**ADDENDUM NO. 01 – PORTAGE PUBLIC SCHOOLS – HAVERHILL ELEMENTARY SCHOOL BP 5:  
FOOTINGS AND FOUNDATIONS**

## ADDENDUM NO. 1 [BP 5]

<b>DATE OF ISSUANCE:</b>	June 15, 2023
<b>PROJECT:</b>	<b>Haverhill Elementary School Bid Package 5: Footings and Foundations</b> 6633 Haverhill Avenue Portage, MI 49024
<b>OWNER:</b>	Portage Public Schools
<b>ARCHITECT'S PROJECT NO.:</b>	21-237.25
<b>ORIGINAL BID ISSUE DATE:</b>	May 25, 2023

SHEET NUMBER  
**A 101A**  
21-237.20

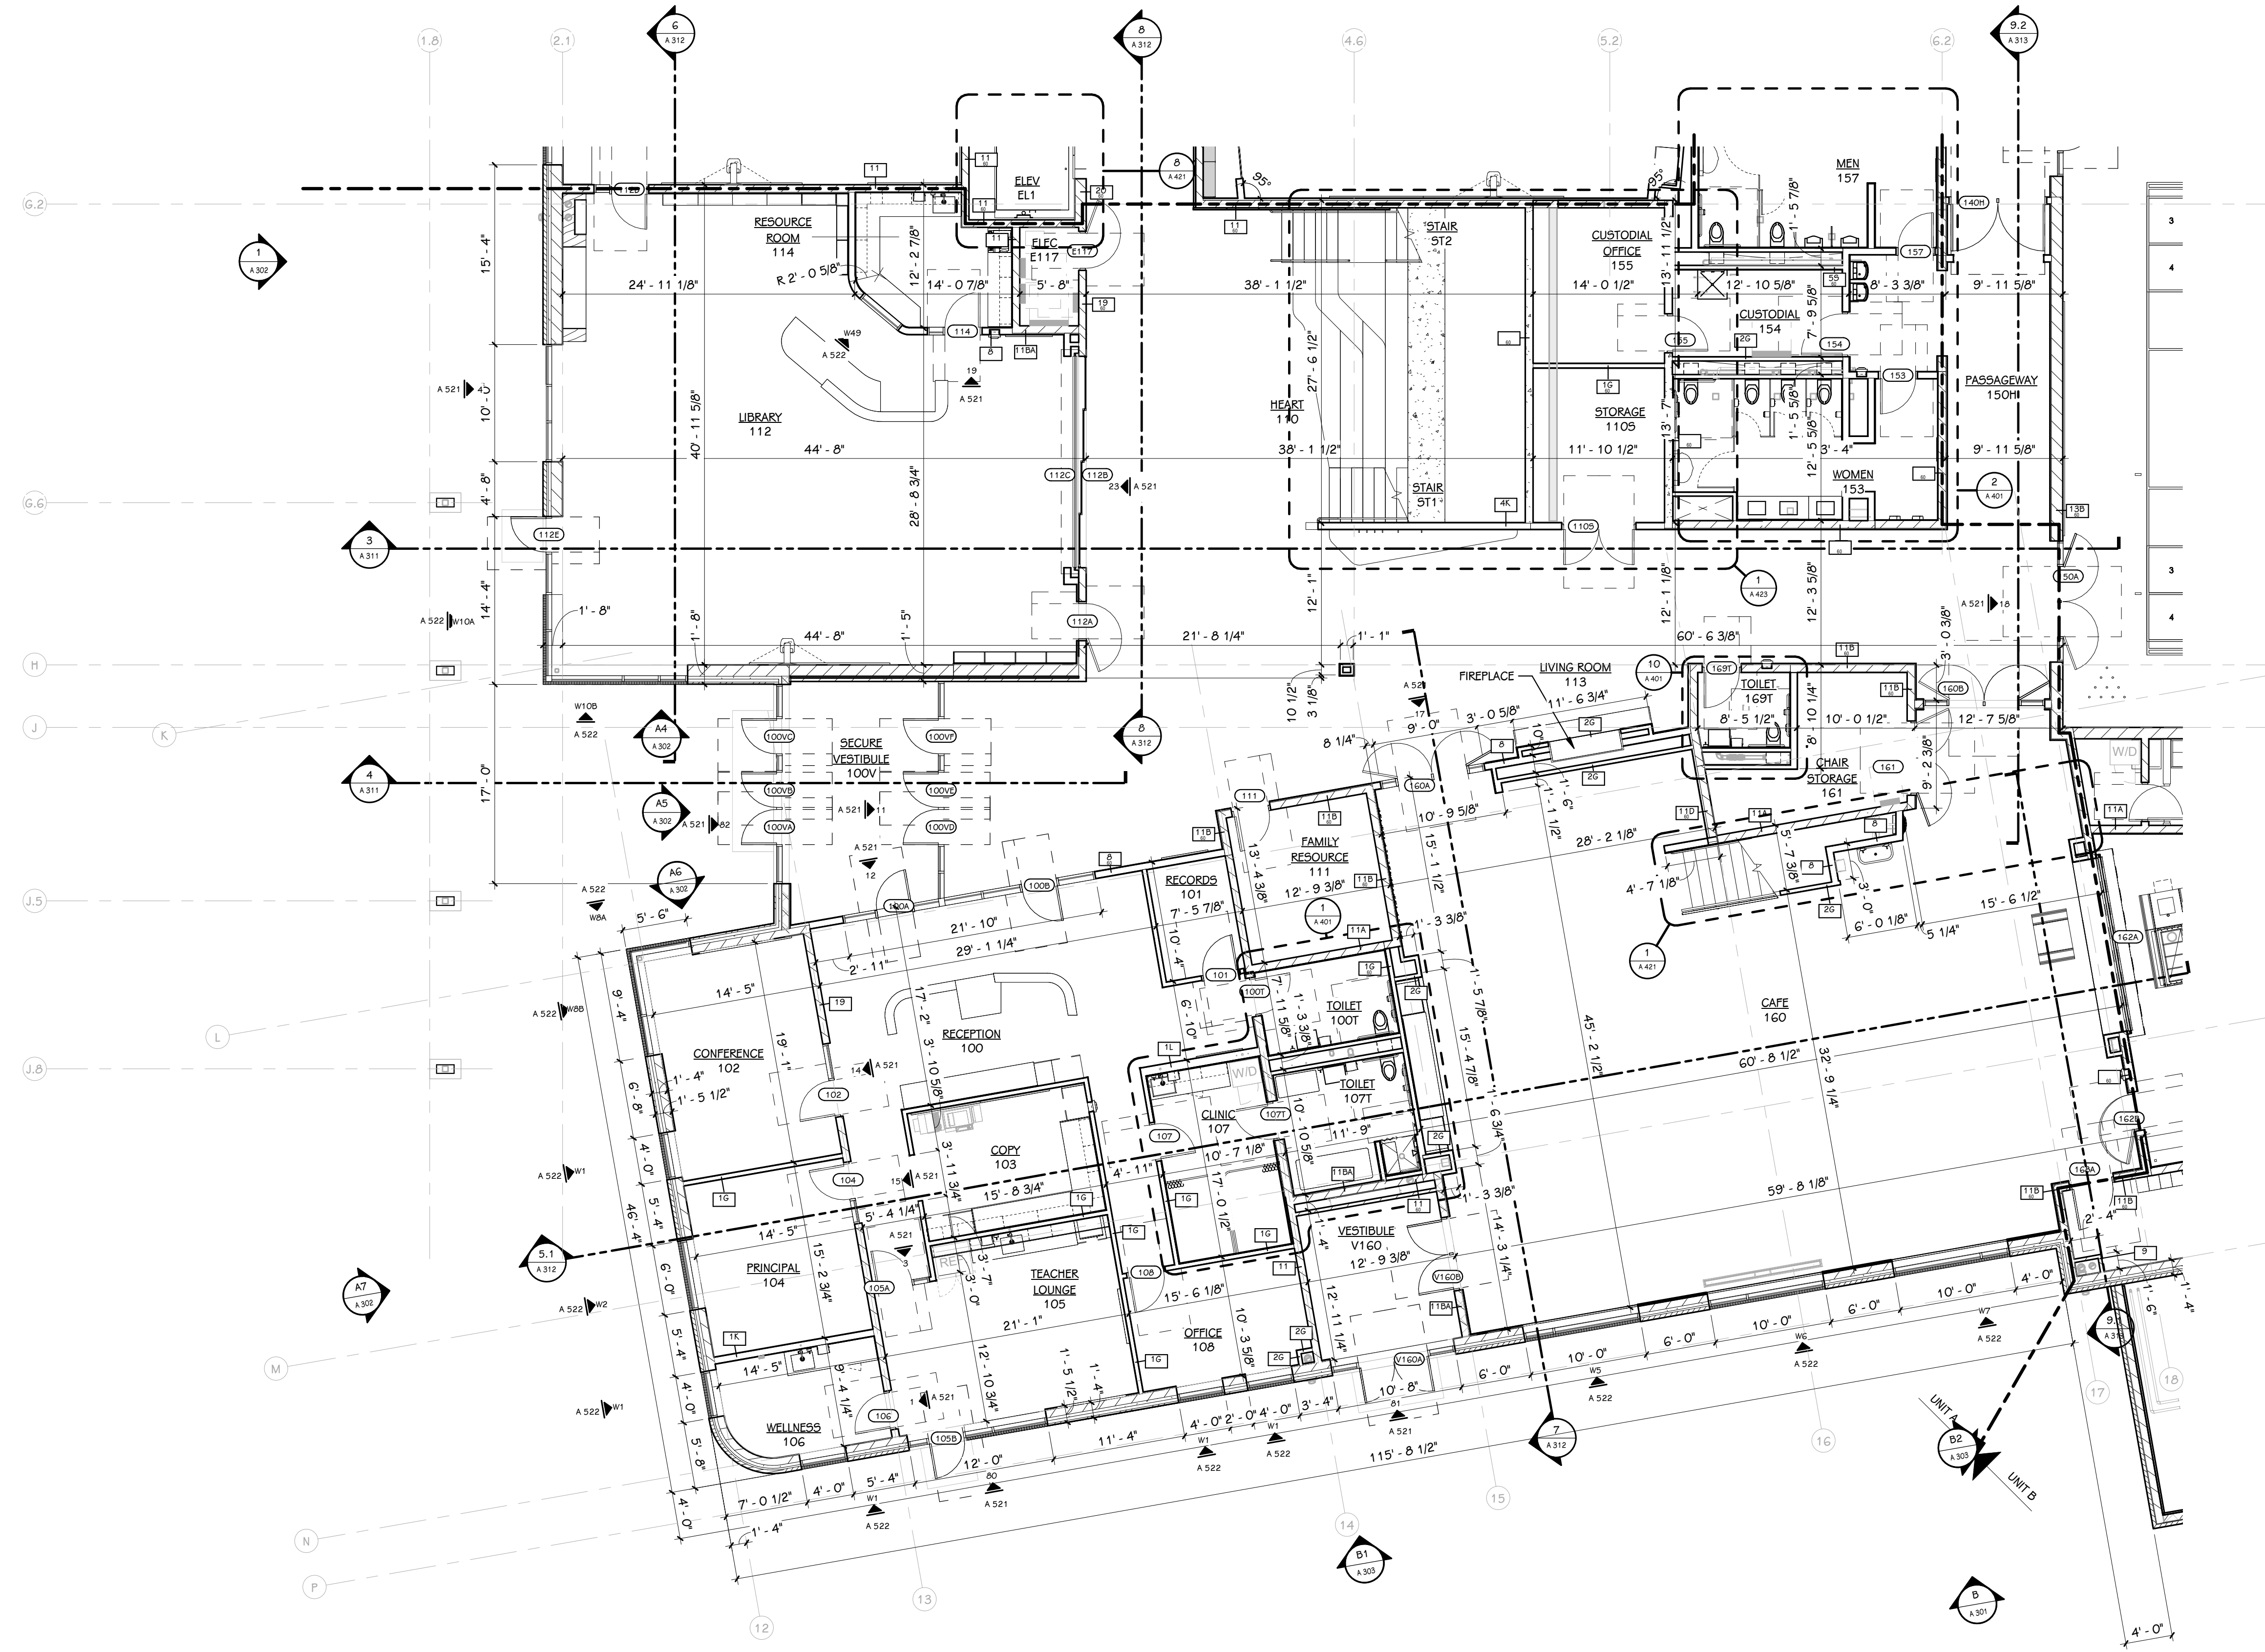
Refer to Sheet(s): G003, A101, A101A, A101B, A101C, A101D

Preliminary architectural first floor plans and interior partition sheet provided for wall widths.
